**PSEG Nuclear LLC**

Salem Generating Station, Units 1 and 2  
Renewed Facility Operating License Nos. DPR-70 and DPR-75  
NRC Docket Nos. 50-272 and 50-311

Subject: **Response to Request for Additional Information – Relief Request  
SC-I4R-133, Alternative Repair for Service Water System Piping**

Figure 1. Detailed Drawing of WEKO Seal

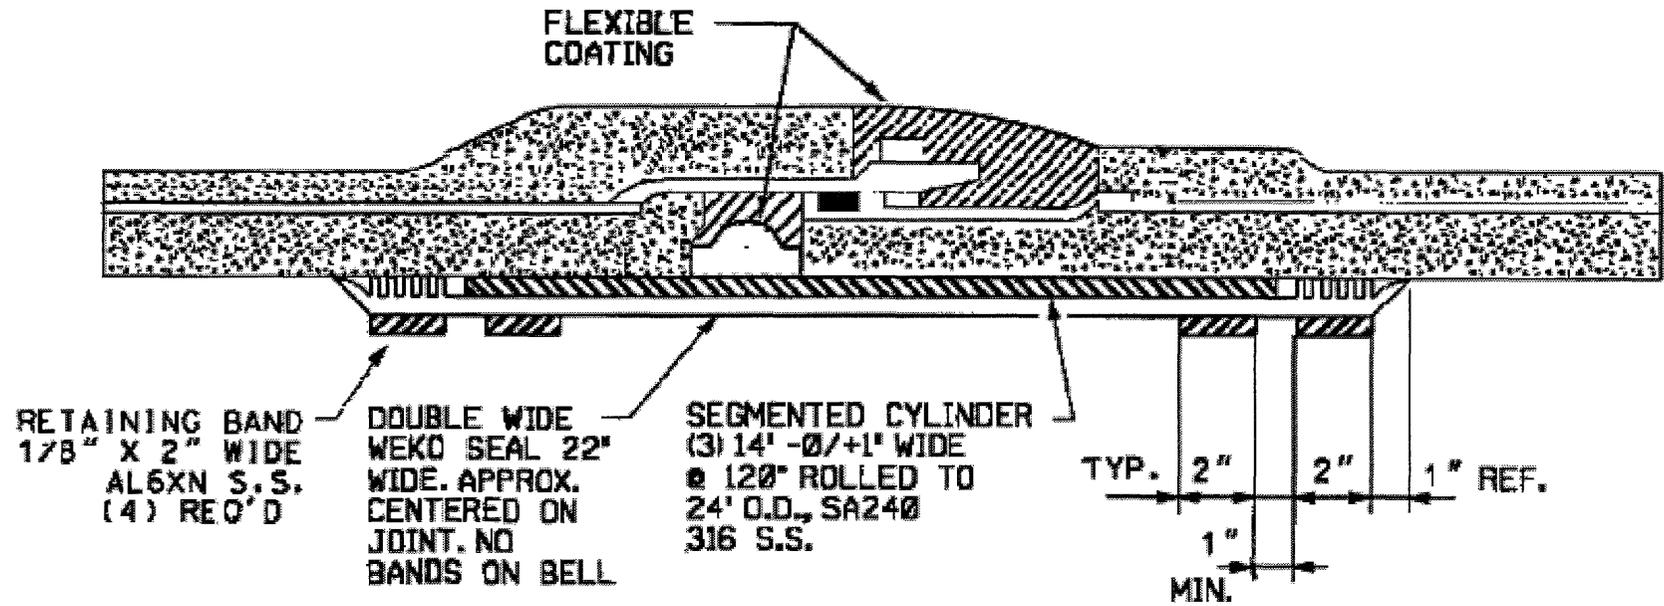
*Provide legible design drawings that show plant-specific dimensions of the items (components) of the bell-and-spigot joint before and after the repair using the WEKO seal. If available, provide 3-dimensional perspective drawings to help the NRC staff to visualize the joint configuration. The drawing should also include the harness assembly.*

Detailed design drawings with plant-specific dimensions of the bell-and-spigot joint before the repair using the WEKO seal are not available. Figure 1 of Attachment 1 provides specific dimensions for the WEKO seals.

Figure 2. Detailed Drawing of Set Screws

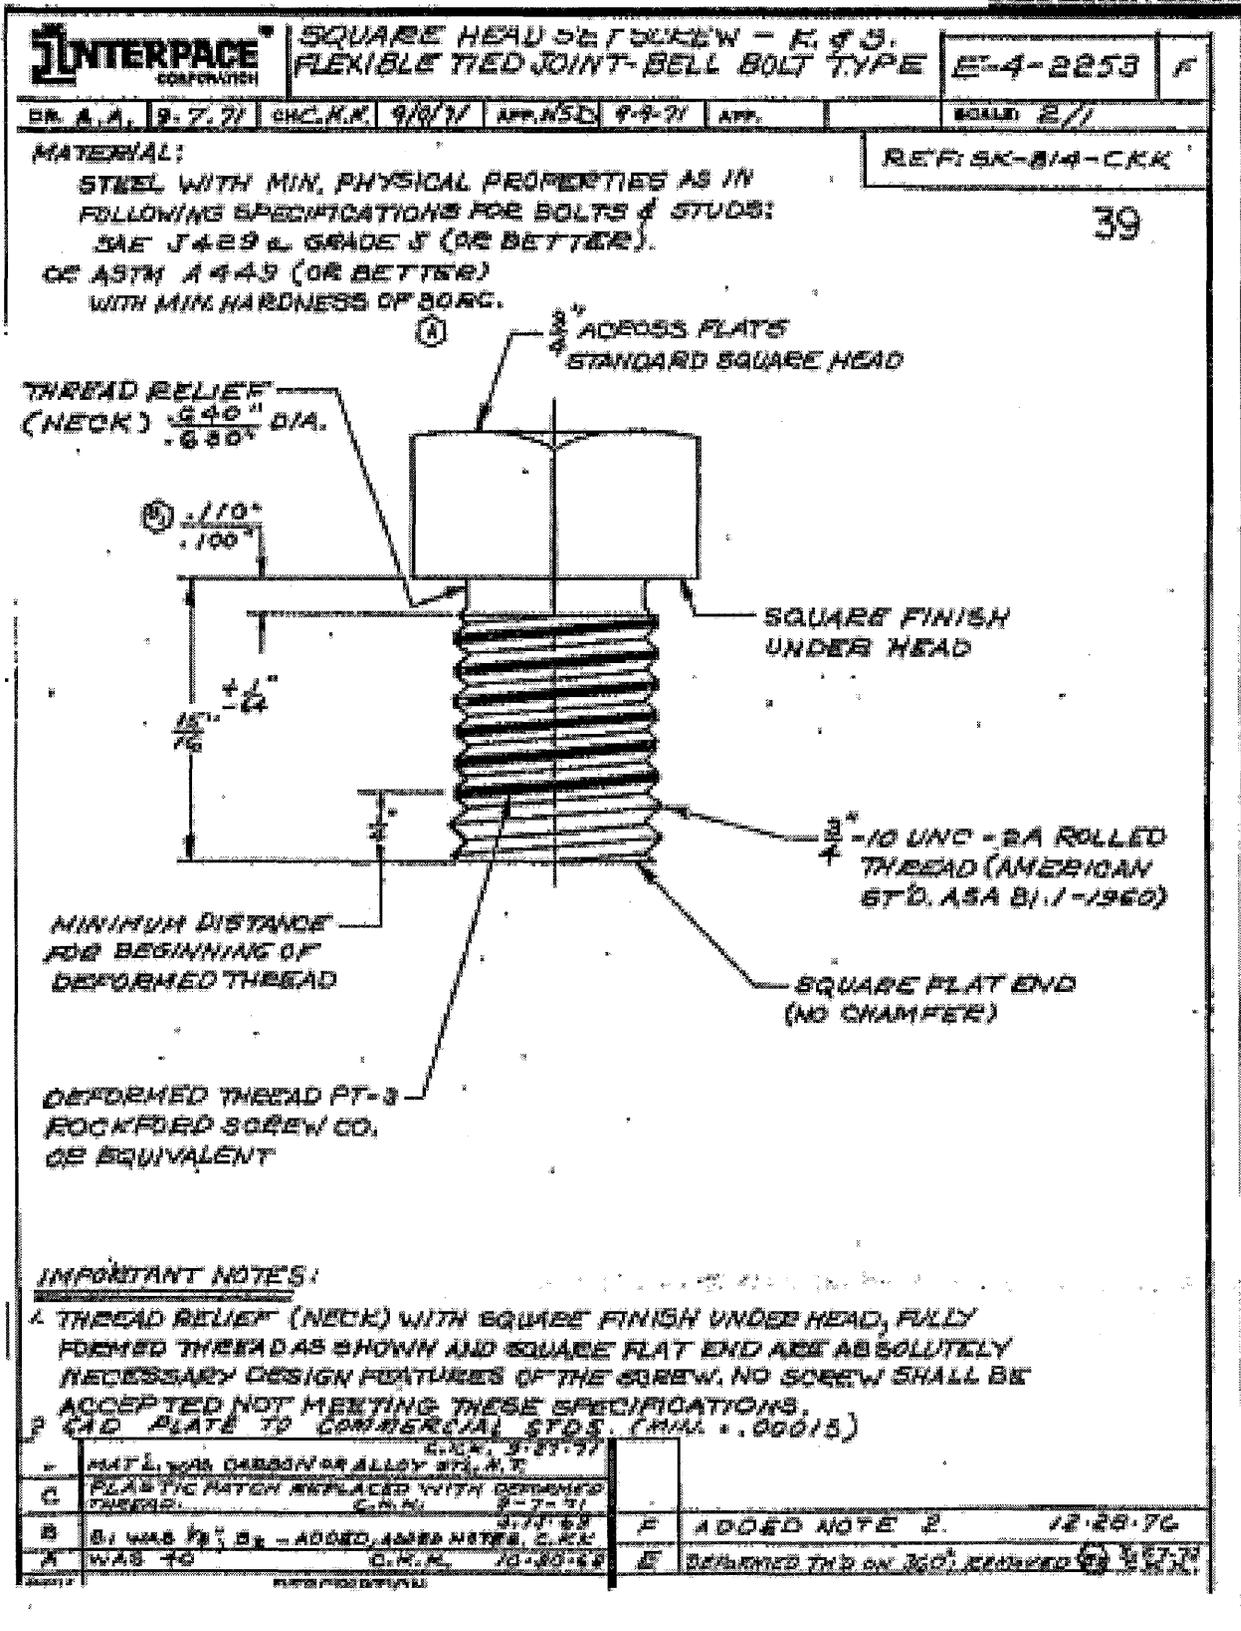
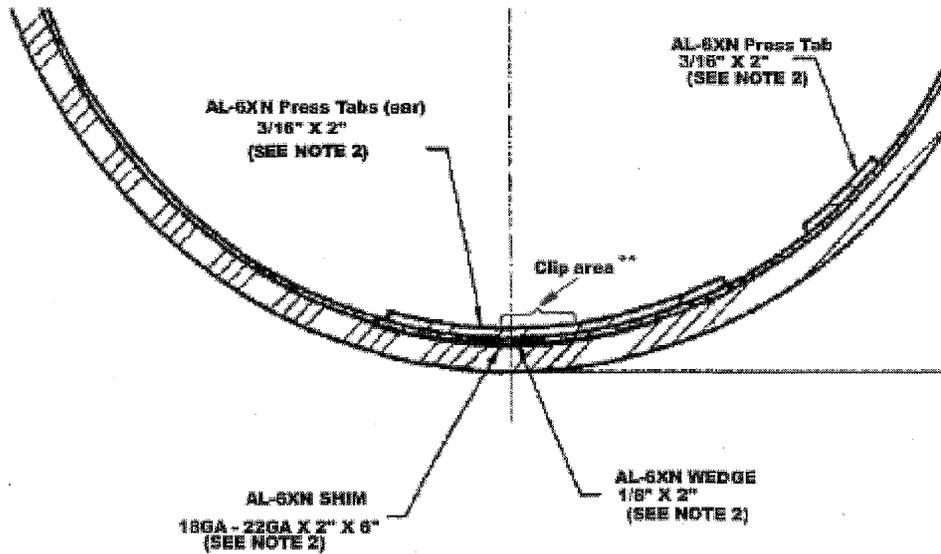
*Provide a detailed drawing of the square head set screws (bolts) and the spigot gasket (not a part of the WEKO seal) showing how the bell and spigot are connected to each other. These drawings will help the NRC staff understand how the pipe loading is distributed and evaluate any potential leak path through the joint.*

Attachment 1, Figure 2 is Interpace Drawing E-4-2253, which is the detailed drawing of the square head set screws (i.e., bell bolts)<sup>1</sup>. A detailed design drawing of the spigot gasket is not available (note that a description of the gasket material is provided in the response to RAI 3). The gasket is an o-ring with a circular cross section that fits into the notch around the circumference of the spigot ring. A sketch of a typical PCCP joint with WEKO seal installed is shown in Figure 4 of Attachment 1 for illustrative purposes. In the installed joint, the gasket seals the gap between the bell ring and the smaller diameter spigot ring, which slides inside the bell ring. There are 24 bell bolts distributed around the bell ring circumference. Each bell bolt is threaded through the bell ring and inserted radially until it contacts the outside diameter of the spigot ring (See Figure 4 of Attachment 1). Note that the bell bolts are not threaded into the spigot, nor are they tightened to load the spigot radially. In the event that adjacent piping segments were to expand, the bell bolt would contact the raised spigot ring end (i.e., the bolt stop), preventing separation of the joint. In effect, the bell bolt would act as shear restraint to prevent joint separation.

Figure 5. Push Tab Details

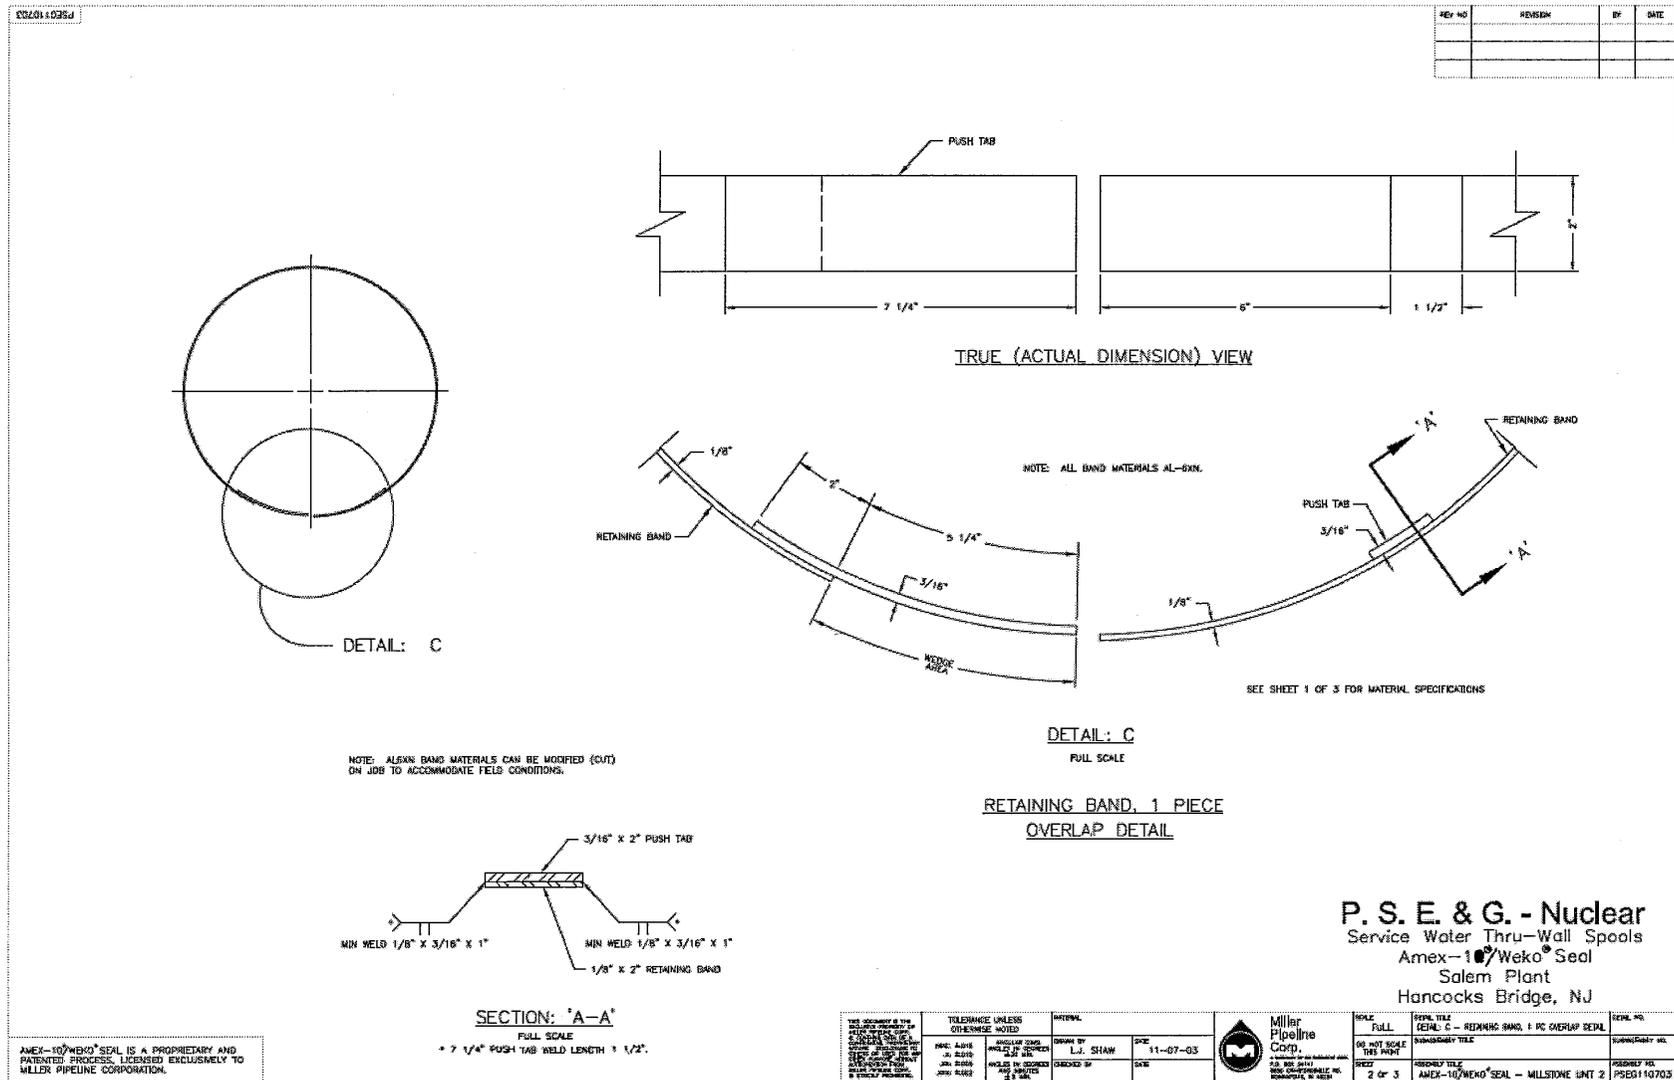
*The fourth paragraph on page 10 states that the maximum shear stress in the push tab welds during installation is 66 percent of the allowable stress. Identify the push tab welds in the design drawings with respect to the WEKO seal assembly and provide a detailed sketch of the push tab itself.*

Figures 3 and 5 of Attachment 1 to this document show the push tabs (also called press tabs) and the push tab welds on a retaining band used for a WEKO Seal assembly.
